BZA Application Form

BZA Number: 151512

Granting the Special Permit requested for <u>38 Cameron Ave</u>, <u>Cambridge</u>, <u>MA</u> (location) would not be a detriment to the public interest because:

MEMORANDUM

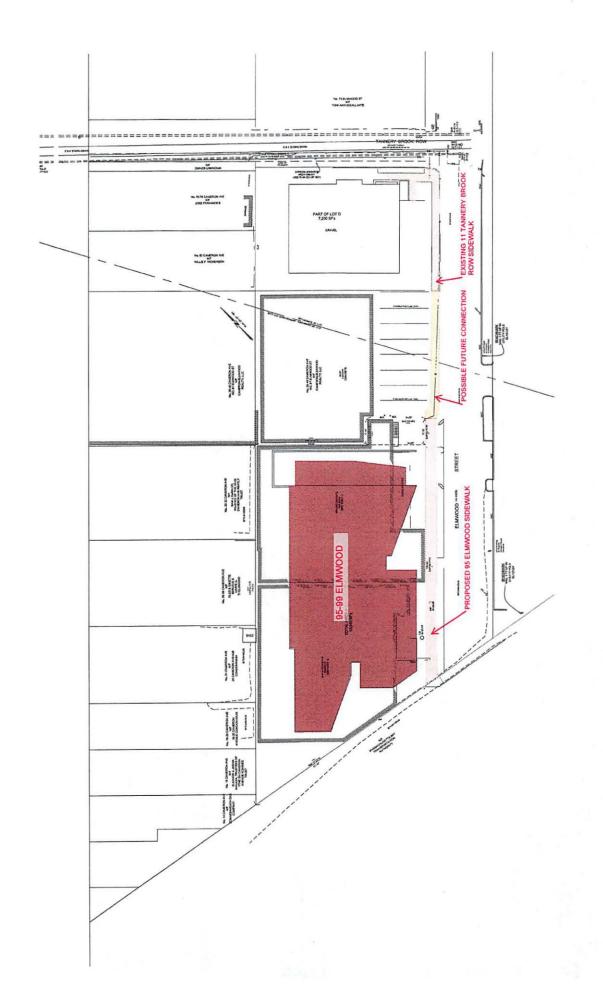
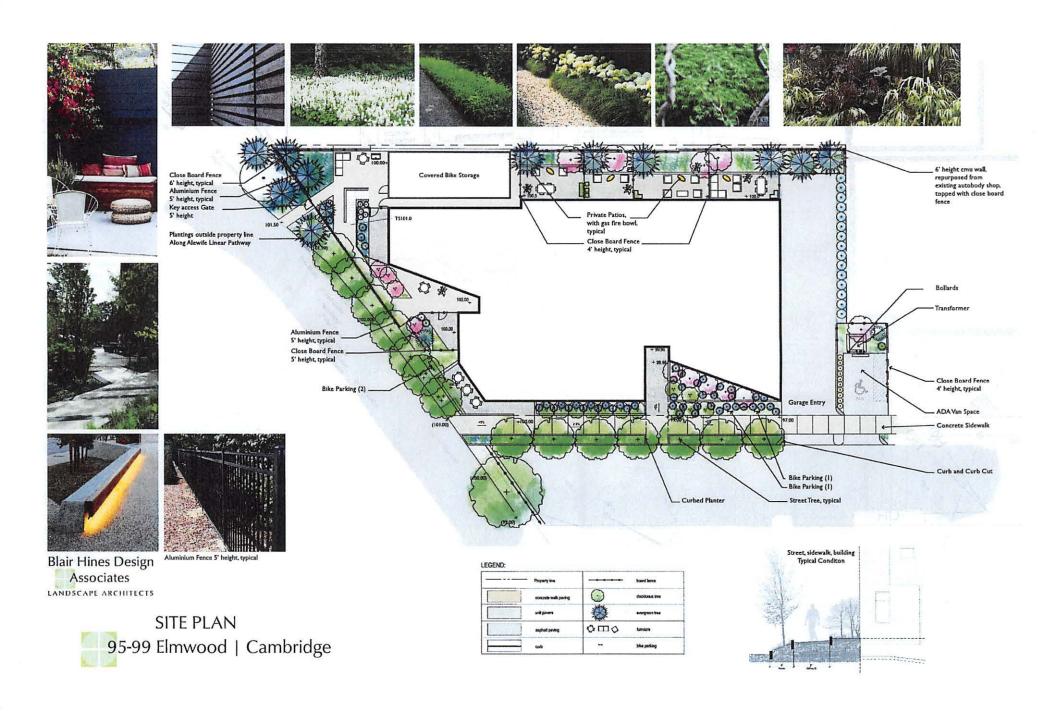
The 38 Cameron Avenue site fronts both Cameron Avenue and Elmwood Street. TP+T believes that the Elmwood Street parking lot (aka 87 Elmwood Street) is the key parking lot in question for this Special Permit.

Elmwood Street is an important connection to the Linear path located at the end of Elmwood Street.

A residential building at 95-99 Elmwood Street which has a Planning Board Special Permit (PB#308) is currently under construction and will be providing a new sidewalk on that property's Elmwood Street frontage to connect to the Linear path. The existing building at 11 Tannery Brook Row located next to this site also has a sidewalk on Elmwood Street. Therefore, there is a missing sidewalk on the Elmwood Street side of the 38 Cameron Avenue site which would be beneficial to users of the site, especially since the site will have more activity with a new wet lab trailer. The sidewalk would also complete the connection on Elmwood Street, between Tannery Brook Row and the Linear path. A diagram showing the missing sidewalk (labeled "Possible Future Connection") is attached. Also attached is the Site Plan for the 95-99 Elmwood Street Project showing that project's future sidewalk on Elmwood Street and how it was expected to connect to this site's future sidewalk.

TP+T believes that the best condition for this site would be to have a raised concrete sidewalk that connects the sidewalks on both sides of the site. Because the proposed plot plan in the BZA Application shows 4 head-in parking spaces on the Somerville side of the parking lot and one parallel parking space on the Cambridge side in front of the wet lab trailer, a long curb cut may be needed, but the concrete sidewalk could be mountable or flush to allow access for those vehicles to park. Another even better option could be to reduce the parking by one more parking space (i.e., not have the one parking

space parallel to Elmwood Street) which would allow for a raised concrete sidewalk for about half the lot and a nicer parking lot condition for the wet lab trailer, such as adding some green space/landscaping between the trailer and sidewalk. Lastly, as a bare minimum condition, a striped sidewalk would be better than nothing.

Lastly, it should be noted that plans show Elmwood Street as a public street, but the City of Cambridge has no records of acceptance for the portion of the Street in Cambridge.
